**TSG-RAN Meeting #13
Beijing, China, 18 - 21, September, 2001**

TSGRP#13(01) 0586

Title: Agreed CRs to TS 25.427

⌘ **25.427 CR 055** ⌘ rev ⌘ Current version: **3.7.0** ⌘

Figure 11: Uplink PLINK data frame structure

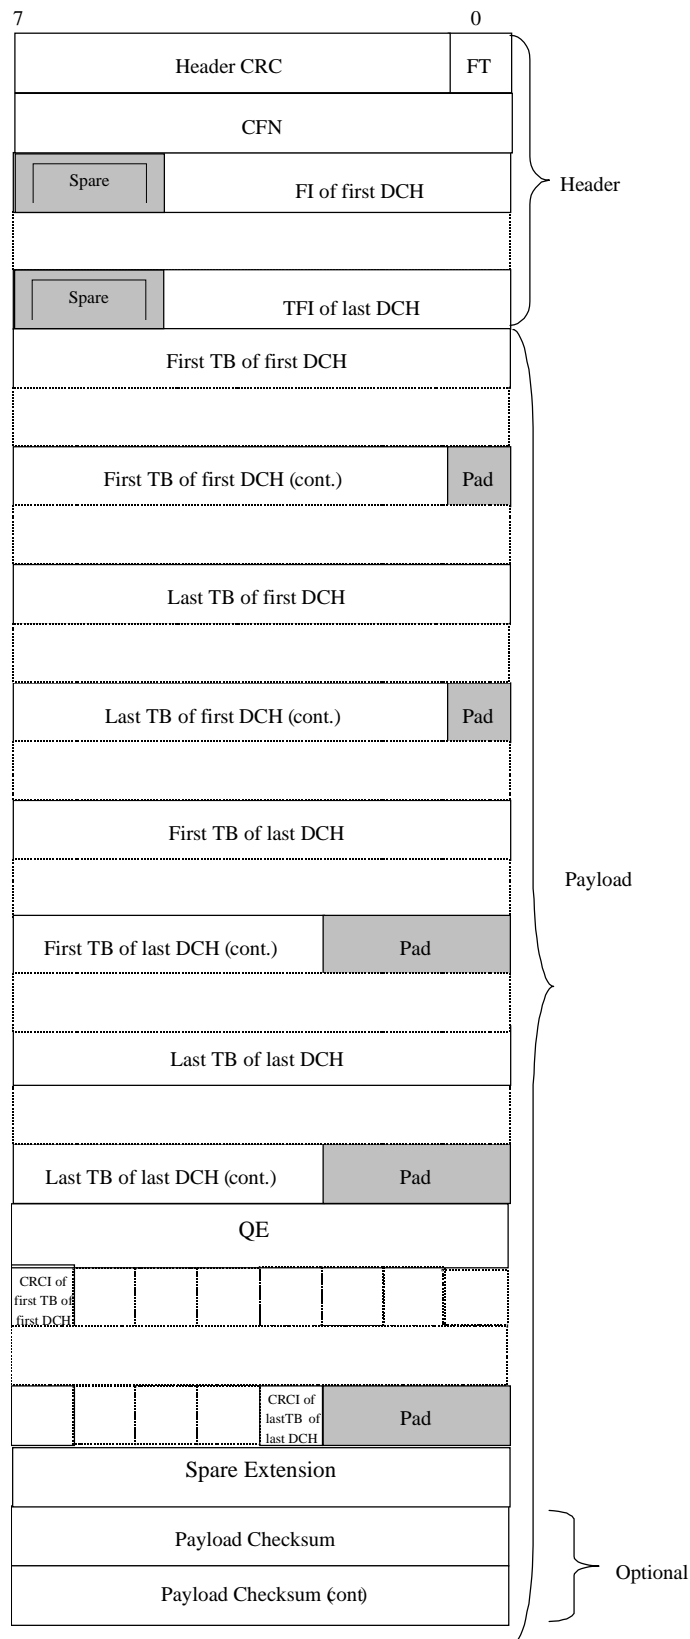
The structure of the UL data DATA frame FRAME is shown below.

Figure 12: Downlink data frame structure

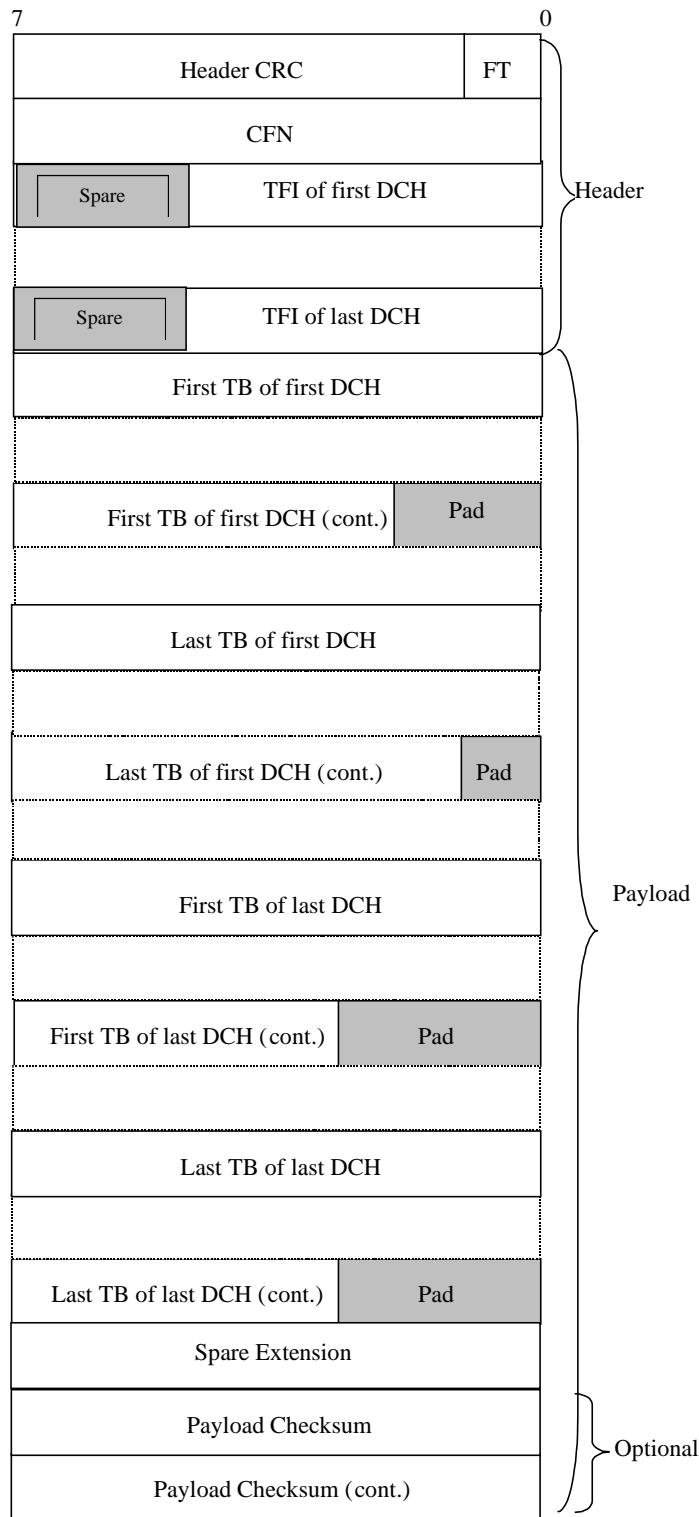
The structure of the DL ~~data~~DATA frameFRAME is shown below.

Figure 22: Structure of the payload for the Radio~~ADIO~~ Interface~~INTERFACE~~ Parameter~~ARAMETER~~ Update~~PDATE~~ control frame

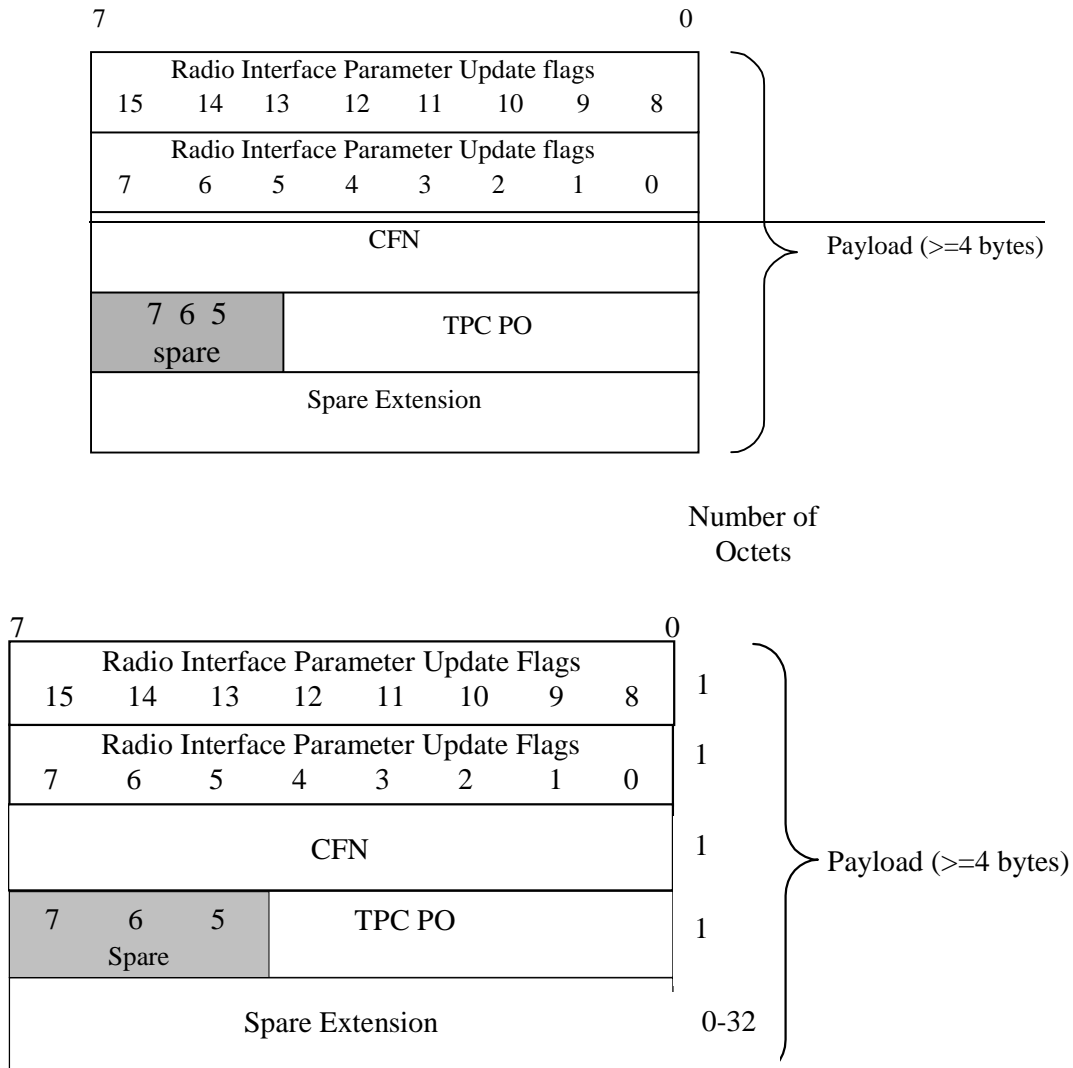
- Bit 0: Indicates if the 3rd byte of the control frame payload contains a CFN (1) or not (0);
- Bit 1: Indicates if the 4th byte (bits 0-4) of the control frame payload contains a TPC PO (1) or not (0);
- Bit 2-15: Set to (0): reserved in this user plane revision. Any indicated flags shall be ignored by the receiver.

Figure 22: Structure of the payload for the Radio Interface Parameter UpdateRADIO INTERFACE PARAMETER UPDATE control frame

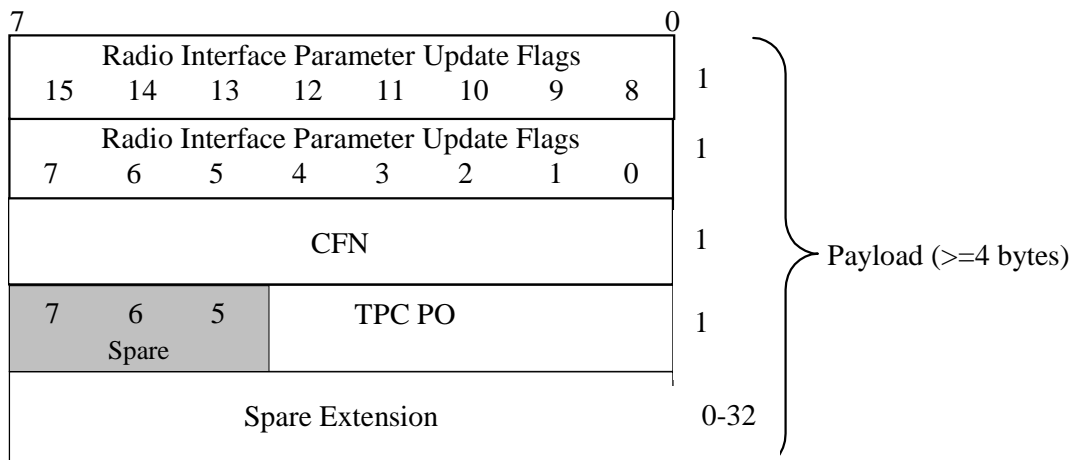
Bit 3-15: Set to (0): reserved in this user plane revision. Any indicated flags shall be ignored by the receiver.
